State Significant Development Modification Report

The Timberyards by RTL Co.

Submitted to Department of Planning, Housing and Infrastructure
on behalf of the RTL Co.

SSD-76927247

Figure 4 Proposed new Building C rooftop communal open spaces

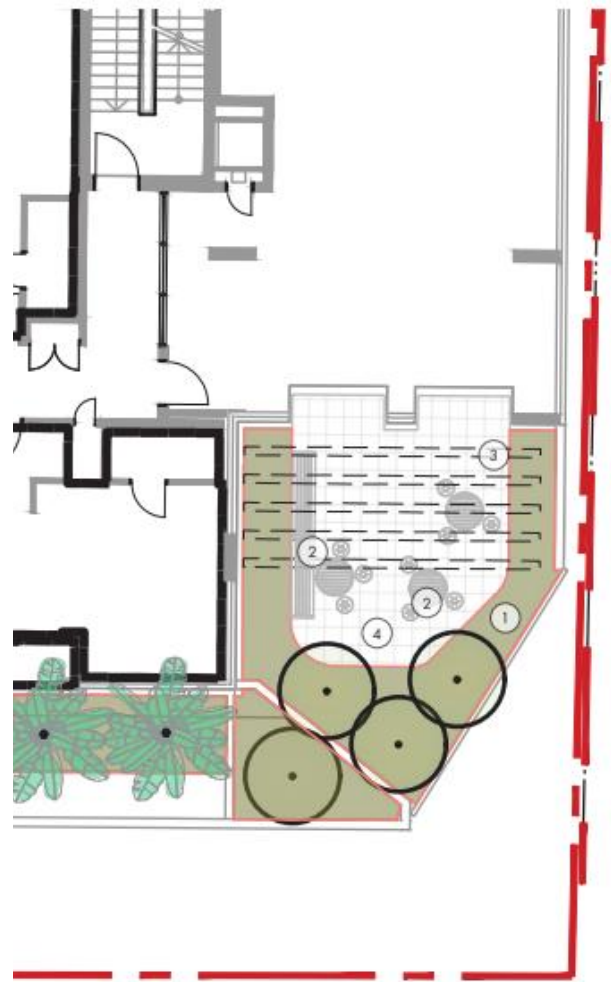
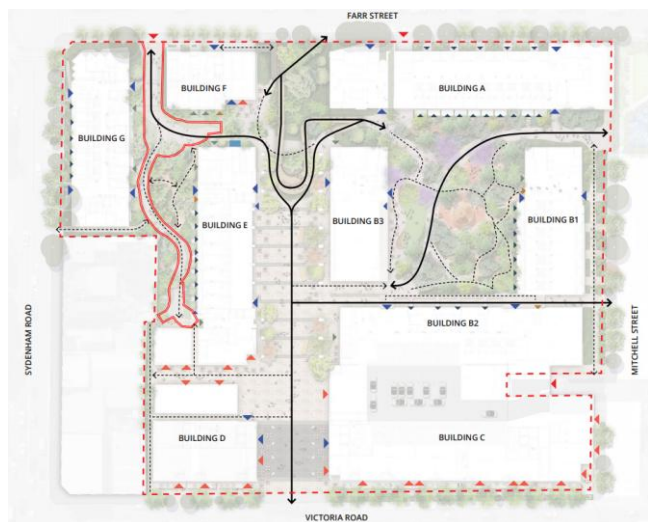
It is proposed to refine the communal rooftop spaces and introduce two additional shared rooftop areas to Building C at Upper Ground Level and Level 5, as illustrated in **Figure 4** below. These amendments are consistent with the approved scheme; however, the spaces have been carefully enhanced to better activate the rooftop environment and provide a softer transition at the Building Edge.

Figure 5 Comparison between approved and proposed site movement and access

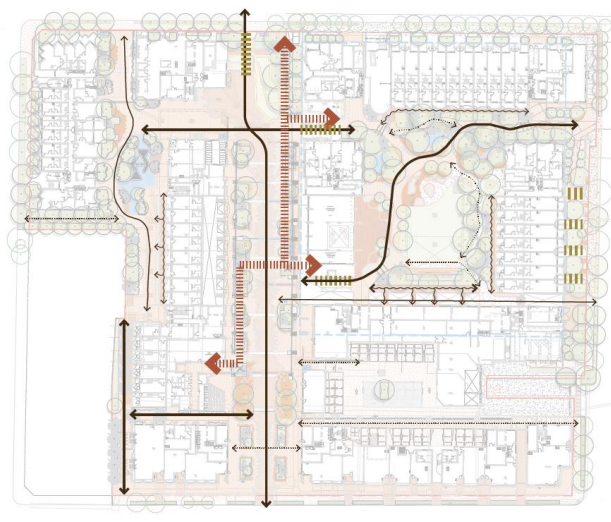
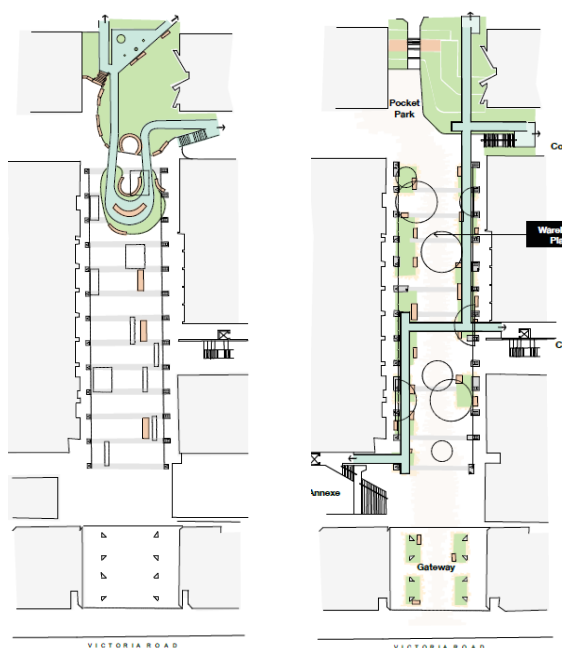
The modification application will revise the layout of the pedestrian network through the site to improve accessibility and wayfinding. The proposed amendments rationalise the number of secondary pathways, which will result in clearer and more direct pedestrian connections throughout the site. Moreover, the hierarchy of the ground plane materials have been strengthened to better define movement corridors.

New walkways through Warehouse Place and a new through-site link between Buildings B and C are proposed. Moreover, the addition of the Building E Annex has created additional landscape laneways bringing users through to the residential mews along the southern boundary line whilst width of the Wicks Alley laneway running along the boundary of Building D has been increased. This has resulted in more generous public realm and greater opportunities for planting and outdoor dining.

A comparison between the approved and proposed movement across the site is shown in **Figure 5** below, with further detail provided in the Amended Architectural Plans and Design Report at **Appendix A** and **Appendix B**, respectively.

Figure 10 Comparison between approved and proposed Building B Level 9 layout

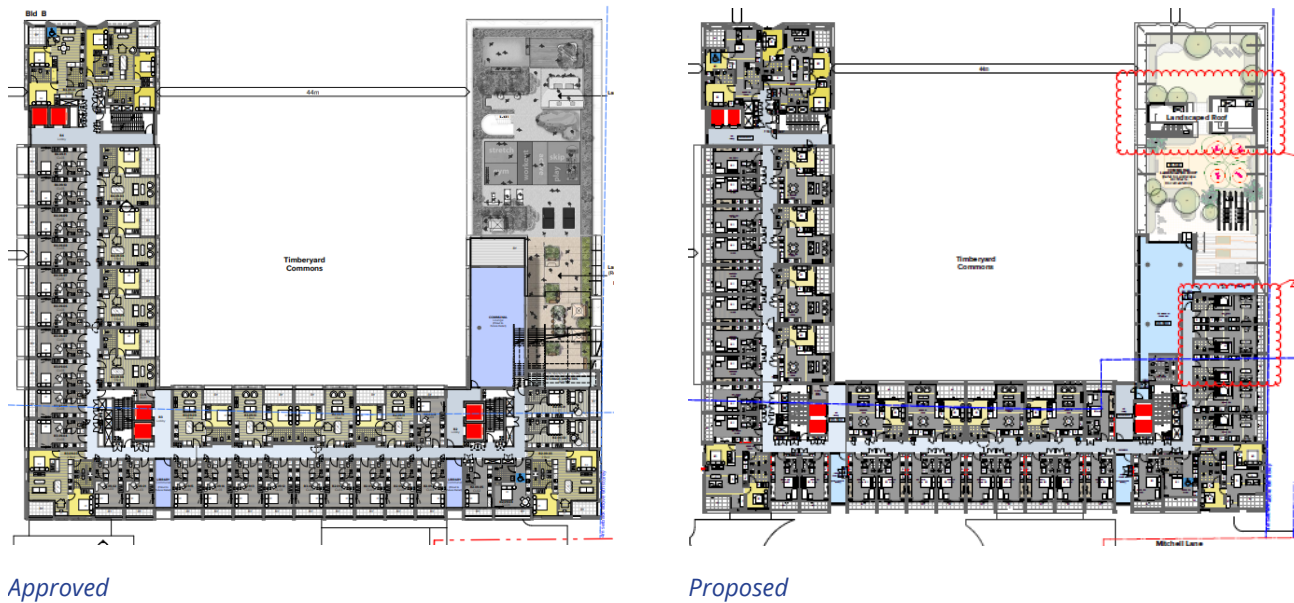
The proposed modifications to Building B include the creation of six (6) new dwellings. The new dwellings within Building B, comprise three (3) studio dwellings, in lieu of some communal area on Level 9 (**Figure 10**) and three (3) co-living dwellings, in lieu of part of a plant room on Level 11, as shown in **Figure 11**.

Figure 14 Comparison between approved and proposed plans for ground floor of Building E

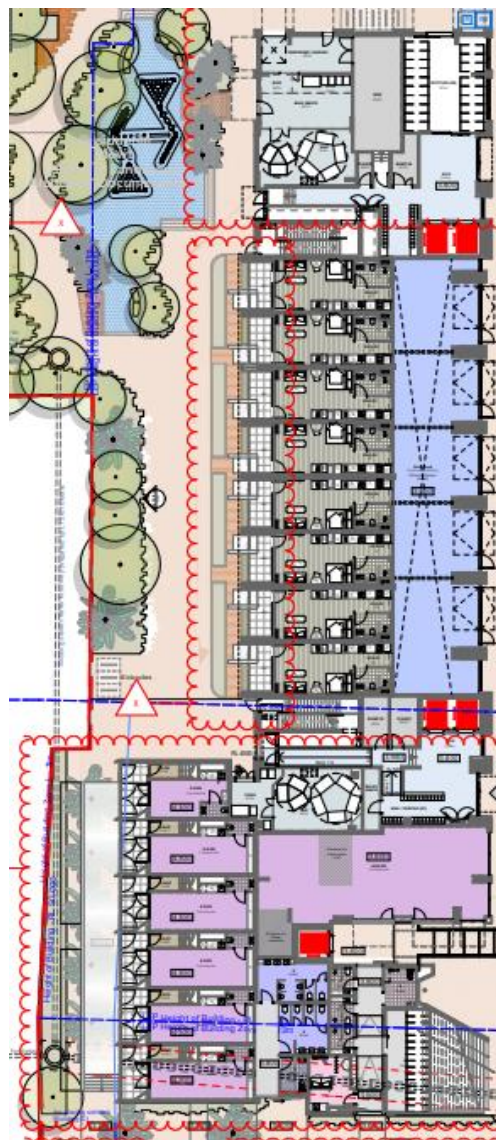
As part of the improved retail strategy, the proposed amendments include a new two-storey annex attached to Building E and expanding its footprint to the south. This new Building E annex effectively replaces the annex that was previously linked to Building D, and will comprise flexible commercial space in the form of new work-live tenancies, new public amenities, a parent's room and end of trip facilities for retail staff.

The creation of the annex will enable new pedestrian connections as it has resulted in a new link between Wicks Alley and the residential mews along the western boundary, improving passive surveillance, whilst also connecting to the new bridge through Warehouse Place. It will also allow for future pedestrian connections through a site link to the corner site.

The annex building is consolidated into two storeys with a 6m setback to the side boundary a generous public landscaped stepped seating facing Warehouse Place. The provision of the new annex building is shown in **Figure 14** below.

Figure 17 Comparison between approved and proposed Building G Level 4 layout

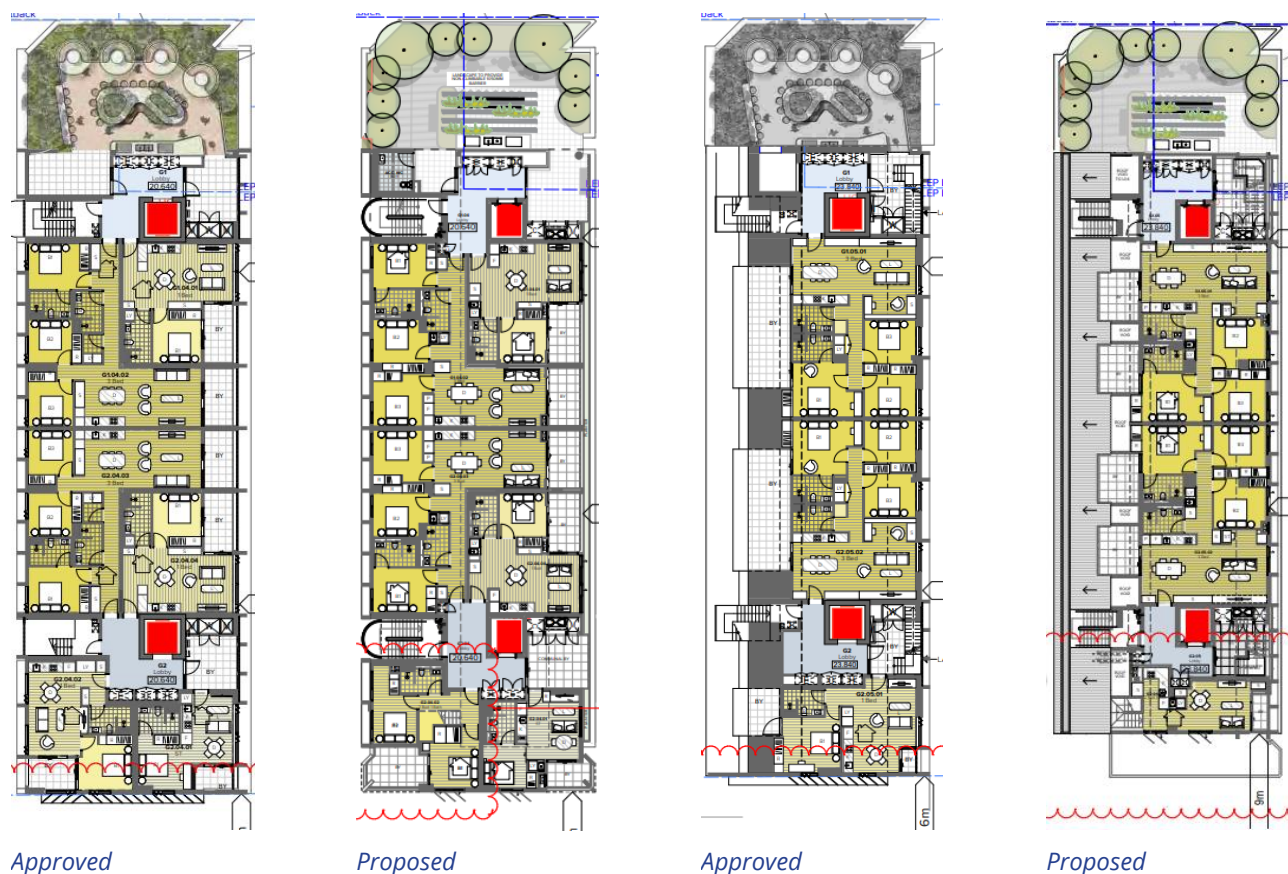
The removal of this mass from the building has an impact on internal plan arrangement, structural design and subsequent elevational expression. Accordingly, internal layouts on Levels 4 and 5 have been redesigned to accommodate the change, and elevations adjusted. The proposed modifications are shown in **Figure 17** and **Figure 18**.

Figure 19 Comparison between approved and proposed basement layout

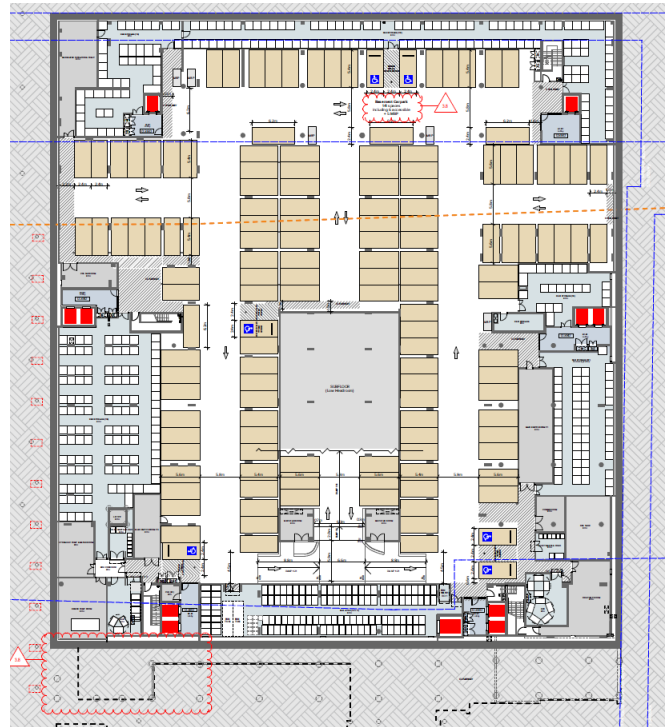
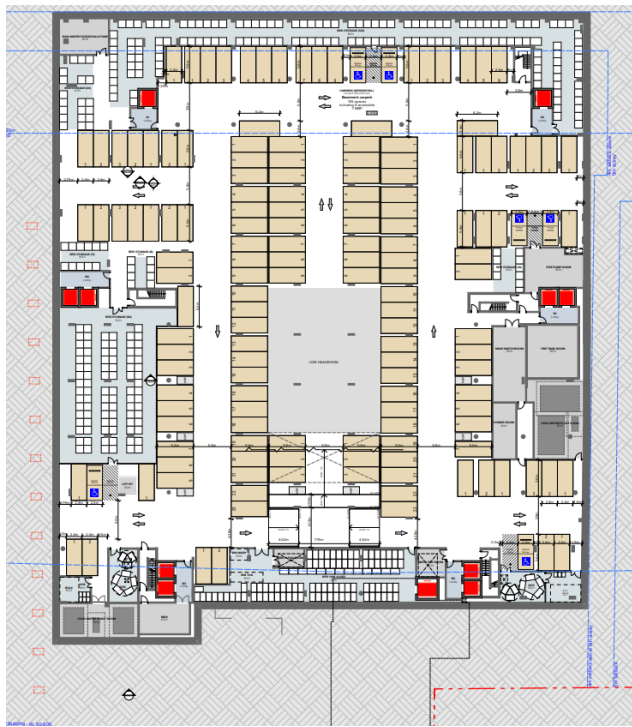
The proposed modifications will consolidate the basement layouts to improve the layouts for plant, storage and car and bicycle parking spaces, as shown in **Figure 19** and **Figure 20** below. Specifically, the following amendments have been made to the parking arrangements:

- Removal of car wash bays; and
- Introduction of 16 new retail parking spaces at the ground level between Buildings B and C.
